JBA Project Code	2026s0324
Contract	Steyne Gardens, Worthing (Arboriculture) 2026
Client	Hemiko – Daniel Reynolds
Day, Date and Time	4 March 2026
Author	Max Ferretti ND Arb, TechArborA
Reviewer / Sign off	Stephen Tester BSc (Hons) MArborA, MICFor
Subject	Assessment of HDD Installation in Relation to BS5837:2012 Trees in Relation to Design, Demolition and Construction

Figure 3 Screenshot of Vertical Section (Drawing Ref: C384-JGL-HDD-XX-DR-C-001001)

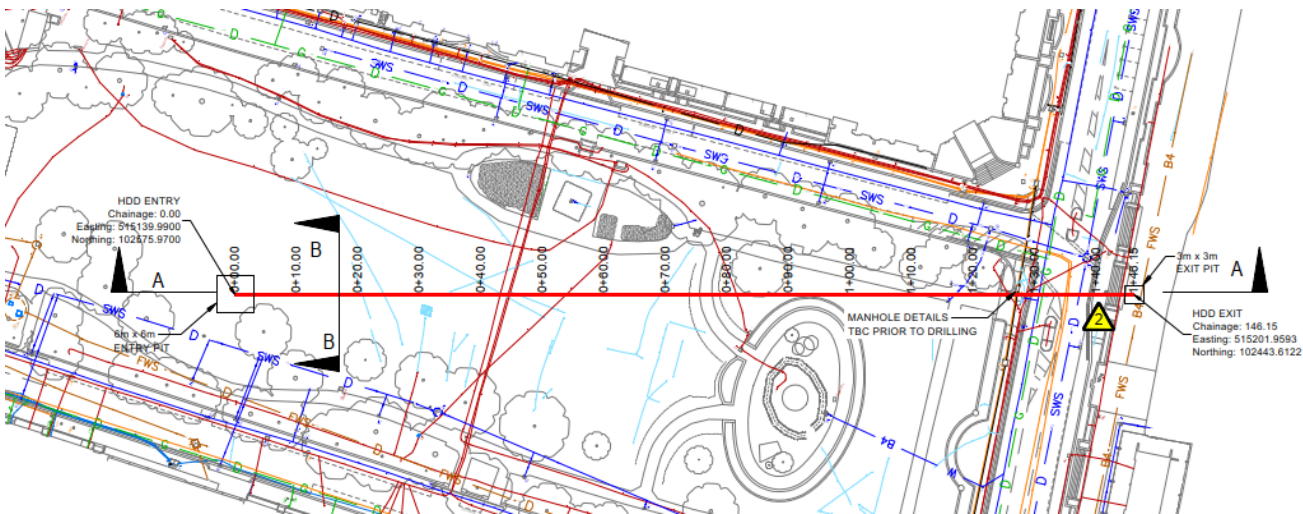
- The Drill depth at lowest point: approx. 8–10 m below ground level (bgl).
- Exit depth into pit: approx. 1.2m bgl.

- Direct root damage is not anticipated from HDD at the deeper sections of the bore.
- The potential for harm exists only at the shallowest sections of each alignment near the pits, where the drill path horizon may intersect the uppermost rooting areas.

Figure 6 Tree Protection Plan with HDD route annotated

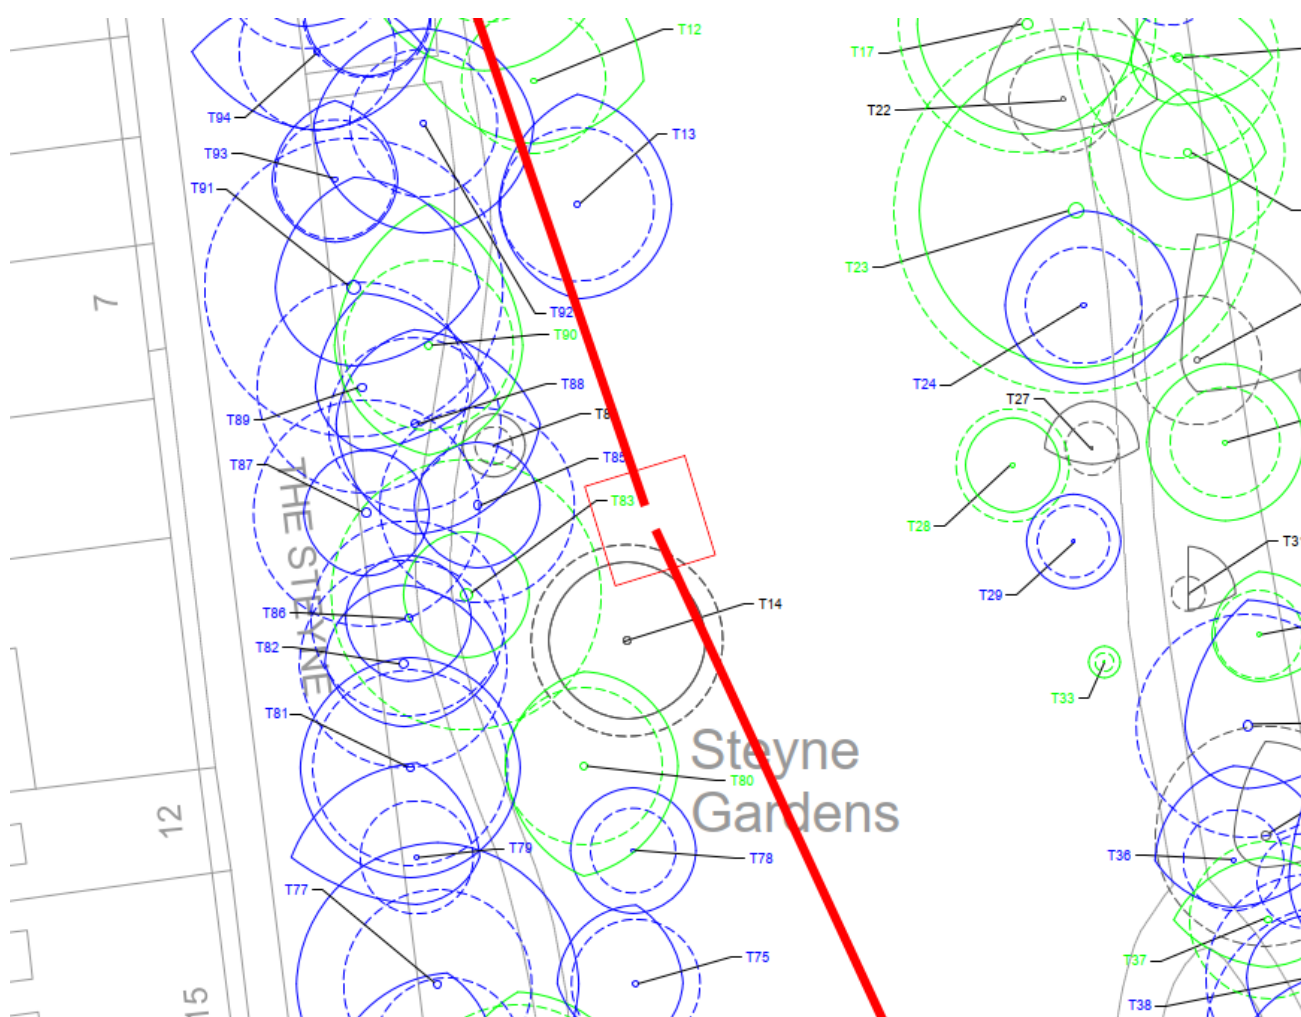
- No open excavation within RPAs unless previously agreed and supervised.
- Drill path remains below 1.0–1.2 m until fully outside RPAs.
- No inadvertent surface disturbance from drilling operations (e.g., frac-outs, settlement).
- Pits in the Gardens to be reviewed in detail due to proximity to mature trees and the rising drill angle.
